APPLICATION NO.	FILING DATE	FIRST NAMED INVENTOR	ATTORNEY DOCKET NO.	CONFIRMATION NO.
09/639,684	08/15/2000	Dennis H. Runnoe	14374.14	4147

Office Action Summary	Application No.	Applicant(s)	
	09/639,684	RUNNOE, DENNIS H.	
	Examiner	Art Unit	
	Courtney Thomas	2882

DETAILED ACTION

Figure 1 - U.S. Patent 5,264,801 to DeCou, Jr. et al.

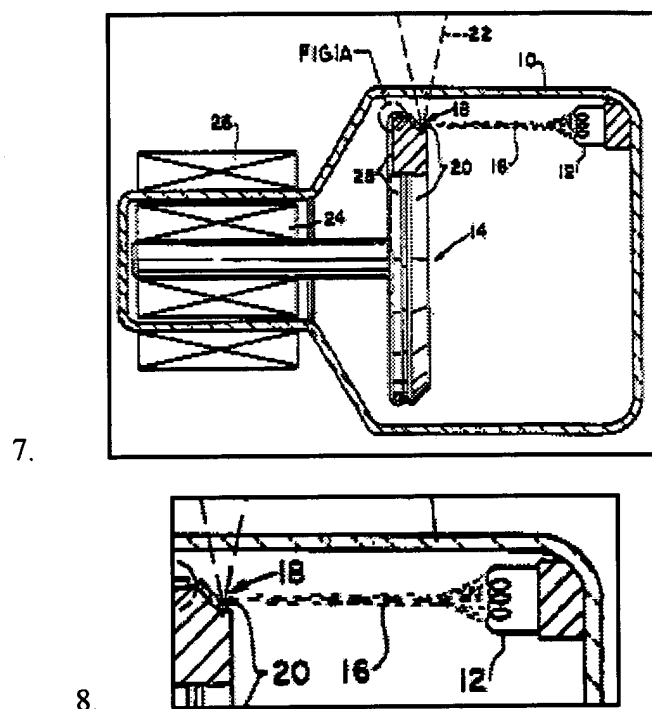
9. As per claims 1, 5, 28, 29, 30, 44 and 53, DeCou, Jr. et al. disclose an x-ray device, comprising:

10. (a) a vacuum enclosure (10),

11. (b) an integral cathode disposed in said vacuum enclosure (note: column 1, lines 14-15 and 17-19, column 2, lines 45-47) said integral cathode including an emitter (12) capable of discharging electrons;

12. (c) a power source (not shown - however, examiner notes that the disclosed device could not operate without a power supply. Additionally, Fig.1, illustrates the emission of electrons upon the application of DC potential; see also column 2, lines 61-65) connected to said emitter so that transmission of power from said power source to said emitter causes said emitter to discharge electrons;

13. (d) a target anode (14) disposed in said vacuum enclosure and having a target surface positioned to receive at least some of the electrons discharged by said emitter;

14. (e) a support cartridge, providing structural support for the emitter (see Fig. 1, above) and

15. (e) wherein the emitter (12) has a predetermined geometrical configuration oriented to cause at least some of the discharged electrons to converge to a focal spot (see Fig. 1, above; see also column 2, lines 61-65).

16. **As per claims 2 and 6**, DeCou, Jr. et al. disclose an x-ray device wherein the focal spot (18) is located proximate to the target surface of said target anode (14); (see Fig. 1 above).

17. **As per claims 3 and 7**, DeCou, Jr. et al. disclose an x-ray device further comprising a support cartridge (not labeled), the support cartridge receiving the emitter and maintaining the emitter in a desired geometrical configuration.

18. **As per claims 11-16, 18, 31-39, 41-43, 45-52 and 54-56** DeCou, Jr. et al. disclose an x-ray device wherein the support cartridge comprises at least one conductive portion, the electron beam and focal spot being selectively manipulated by the application of a voltage to the at least one conductive portion (i.e. Fig.1), the emitter comprises a plurality of subsidiary emitting portions integral with each other, at least two subsidiary emitting portions not being parallel to each other while cooperating to facilitate the convergence of at least some of the discharged electrons (see Fig. 1 above), wherein the at least two subsidiary portions are integral with each other and are disposed in a substantially "V" shaped configuration (see also Fig. 1 above); wherein a plurality of cut out portions are defined in the emitter, the plurality of cutout portions collectively defining an electrical current path; the emitter substantially comprises a single piece of emissive material, at least one of a subsidiary emitting portion is substantially planar, at least

one of a subsidiary emitting portions substantially comprise a geometry selected from the group consisting of parabolic and spherical sections (see Fig. 1 above and respective portions of the specification).
